A.C. Wright Design	
Sheet: /	
File: ACE_RAM_Patch.kicad_sch	
Title: ACE RAM Patch	
Size: A4	Date: 2026-09-24
KiCad E.D.A. 10.0.3	Id: 1/1
	Rev: 1.1

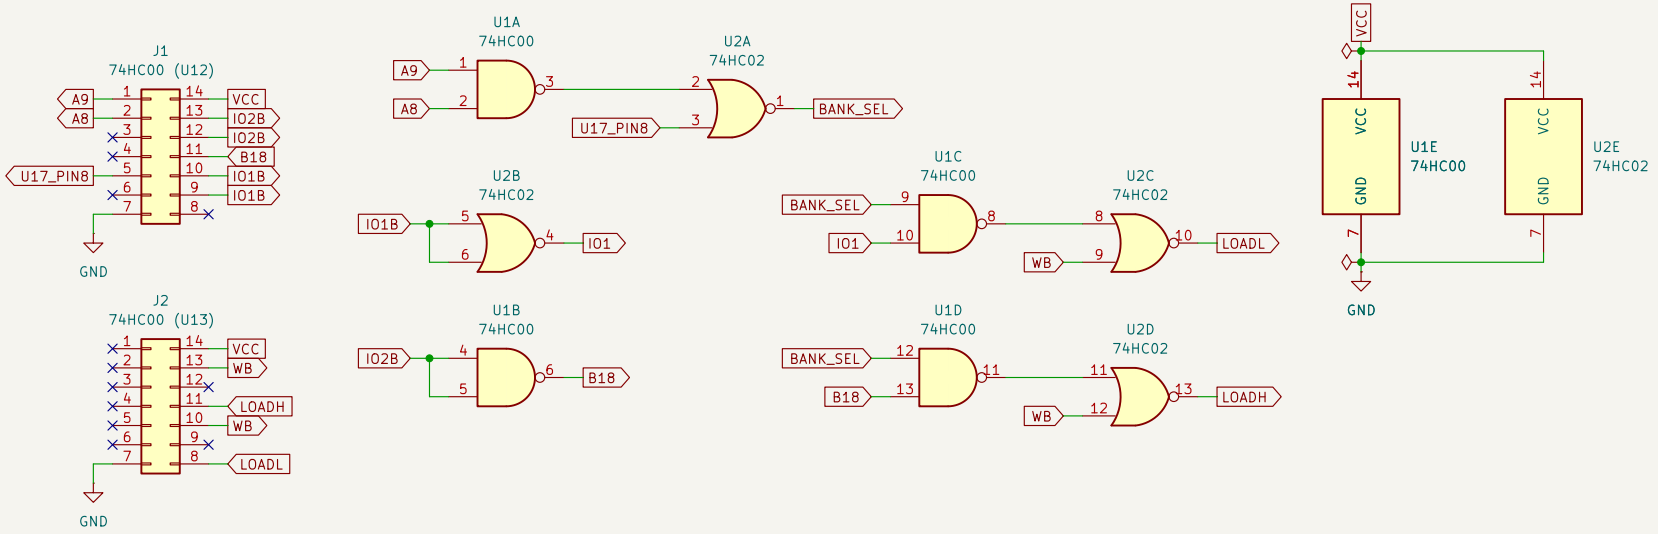
Fitting: take U12 and U13, chips and sockets, off the Rev 1.0 ACE Board. The patch mounts underneath it, front side up: pin headers from J1 go into U12's holes and from J2 into U13's, soldered on both boards. U1 and U2 are on the back, hanging below; trim their leads flush on the front. U13's pin 1 is 23.00 mm from U12's along the row, so J2 sits 23.00 mm from J1.

LOADL and LOADH go high only on a write to the bank register, $83FF or $87FF, while PHI2 is high: A9·A8·(A0–A7 all ones), with IO1 for LOADL and B18 for LOADH, and /WB. U17_PIN8 is the 74HC30's output, /(A0–A7).
